Paycor Stadium Southeast & Southwest VT Escalator Towers
Bid Package 3: Architectural & MEP
ITB#037-26
Addendum 2

May 12, 2026

ELECTRICAL PARTIAL PLANS LEVEL 300 NEW WORK LIGHTING

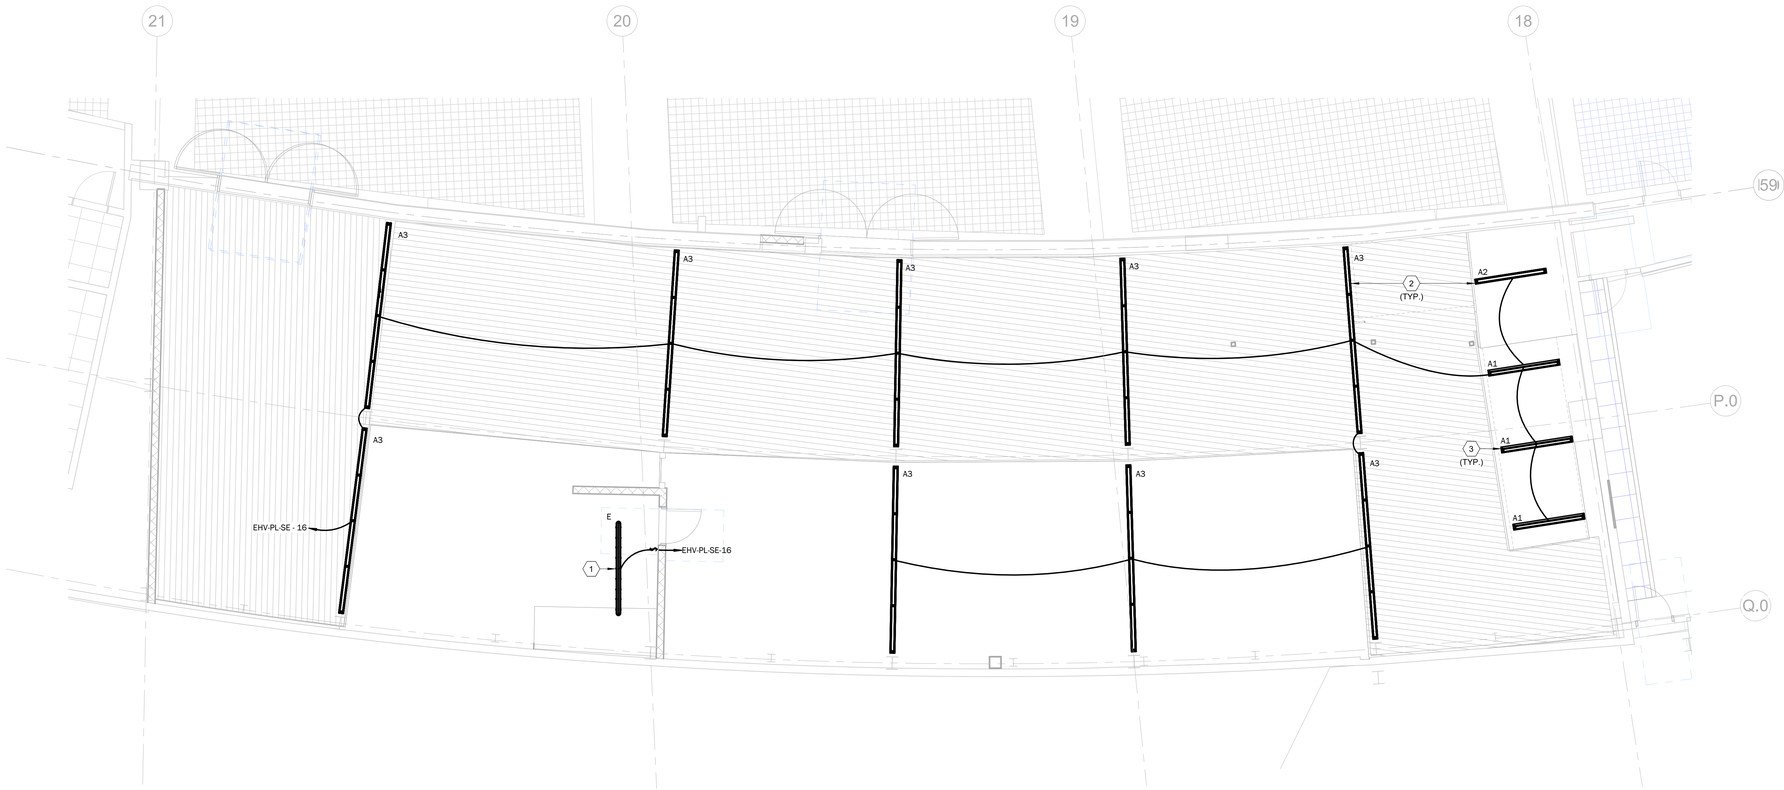
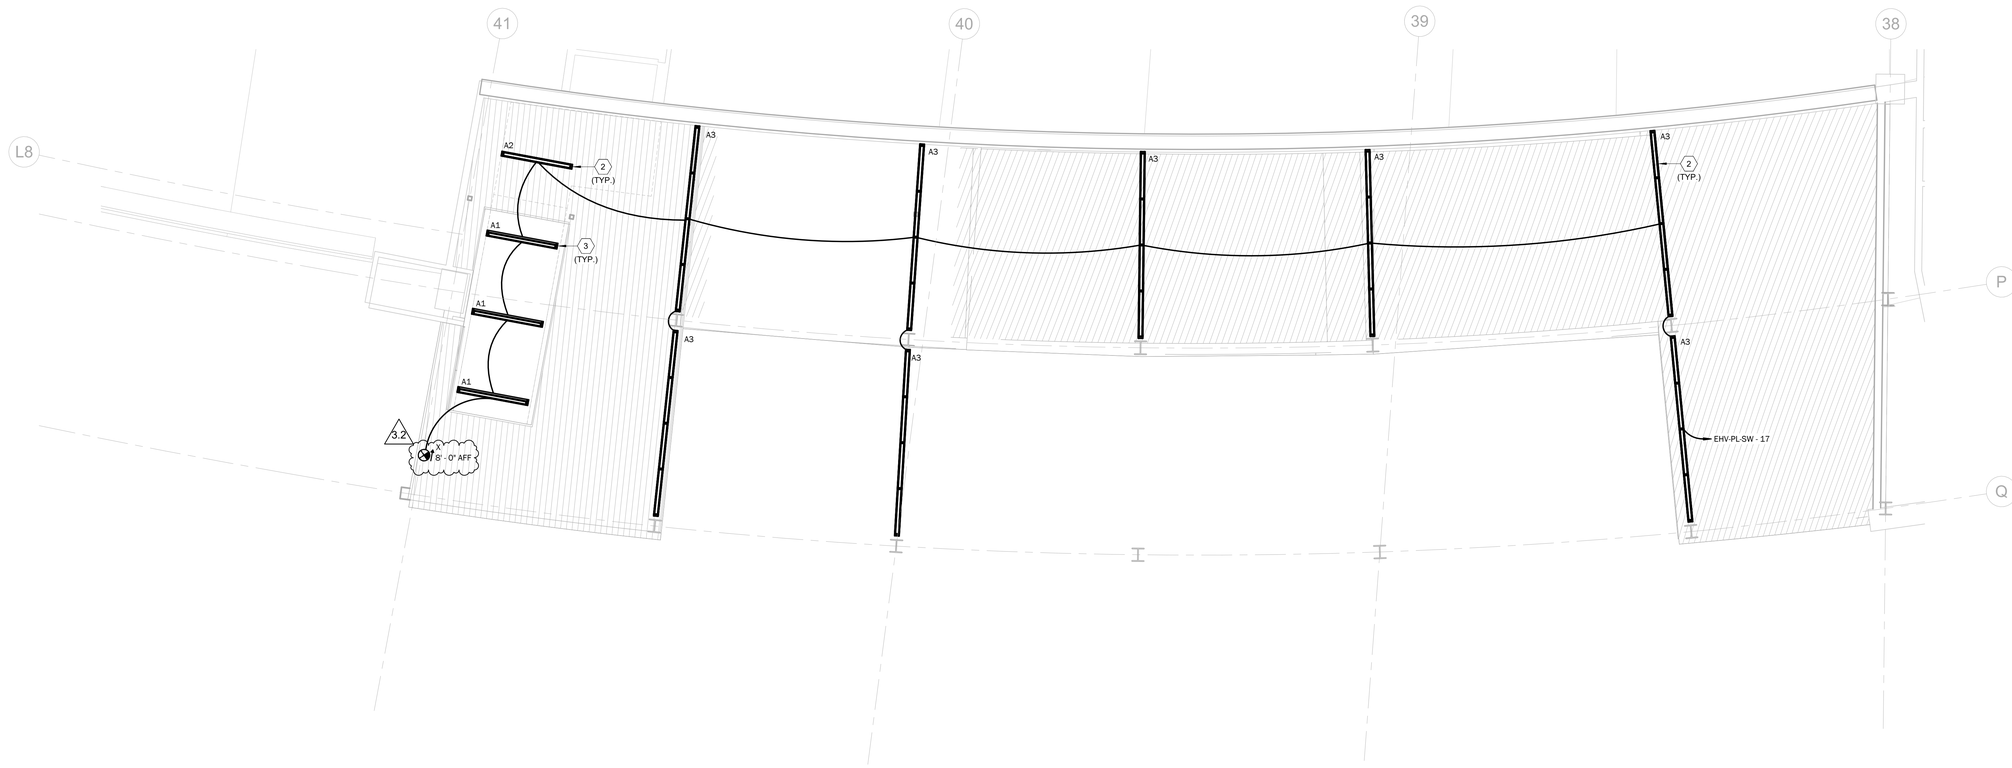
2.27 E207: ELECTRICAL PARTIAL PLANS LEVEL 300 NEW WORK LIGHTING
- 2.27.1 Added exit signs.
- 2.27.2 Deleted General Note.

ELECTRICAL PARTIAL PLANS LEVEL 400 NEW WORK LIGHTING

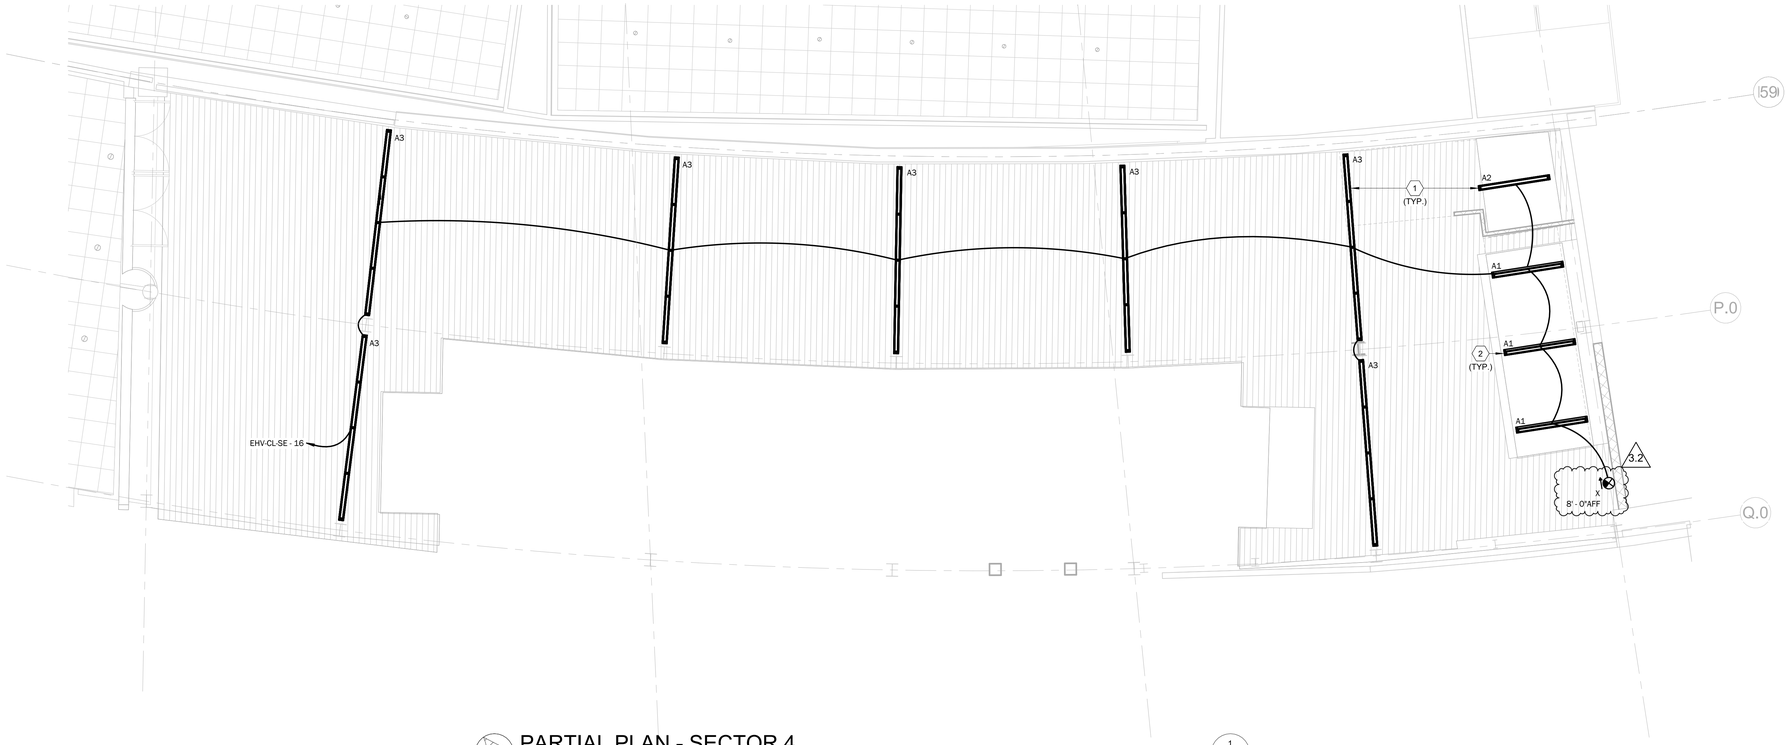
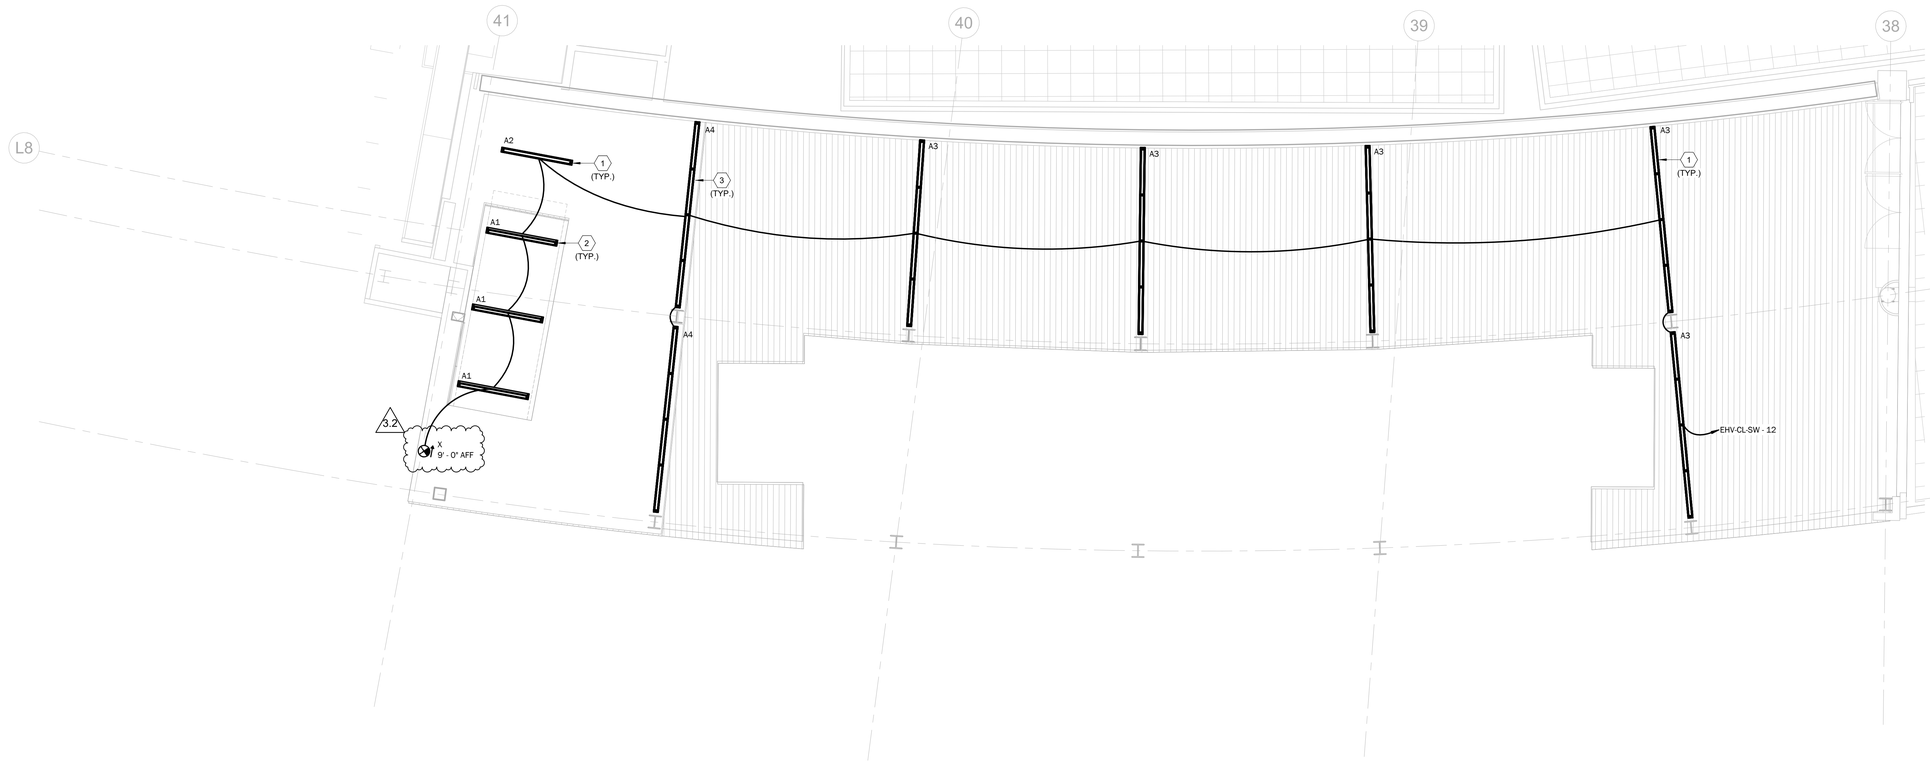
2.28 E208: ELECTRICAL PARTIAL PLANS LEVEL 400 NEW WORK LIGHTING
- 2.28.1 Added exit signs.
- 2.28.2 Deleted General Note.

DRAWING NUMBER	ISSUE
E209	3.2

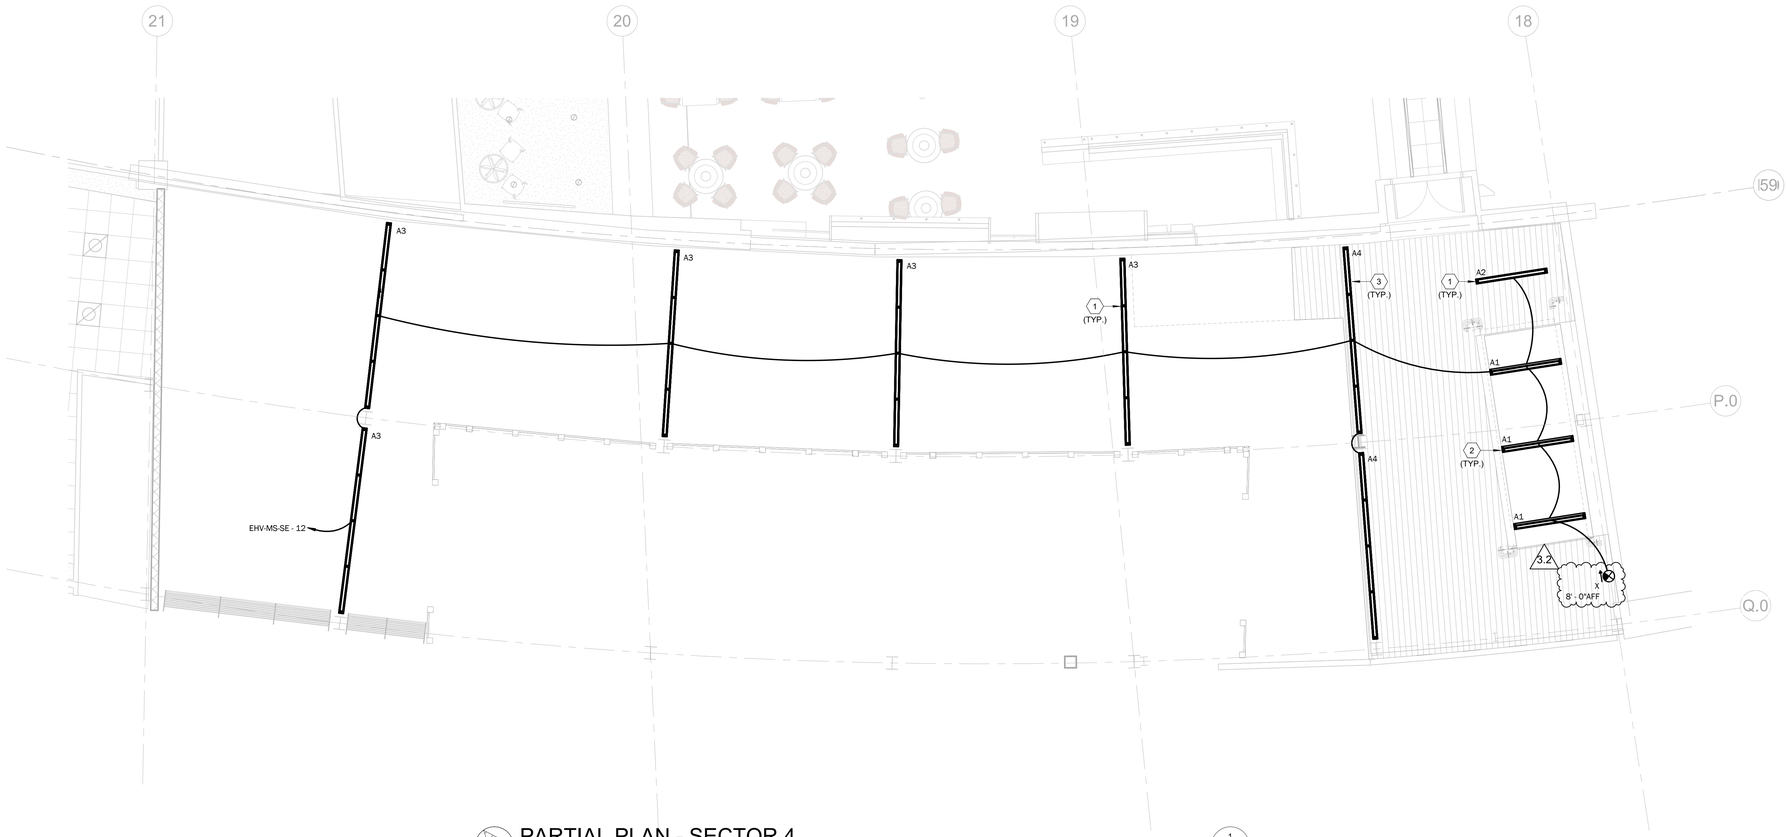
2.29 E209: ELECTRICAL PARTIAL PLANS LEVEL 500 NEW WORK LIGHTING
- 2.29.1 Added exit signs.
- 2.29.2 Deleted General Note.

ELECTRICAL PARTIAL PLANS LEVEL 600 NEW WORK LIGHTING

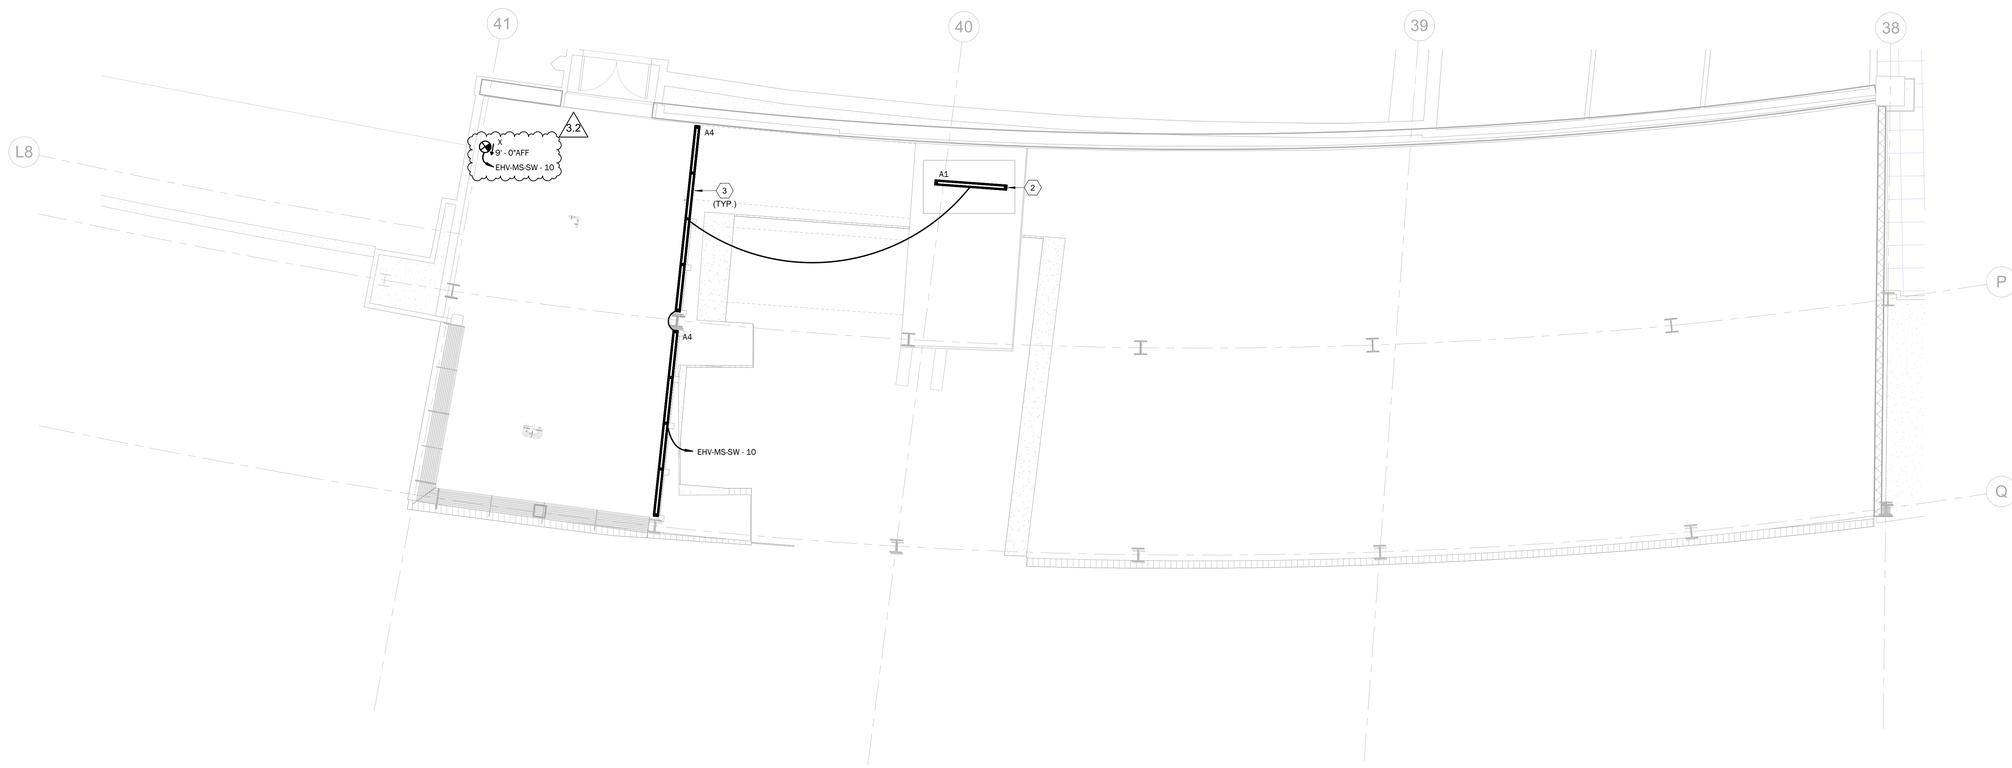
2.30 E210: ELECTRICAL PARTIAL PLANS LEVEL 600 NEW WORK LIGHTING
- 2.30.1 Added exit signs.
- 2.30.2 Deleted General Note.
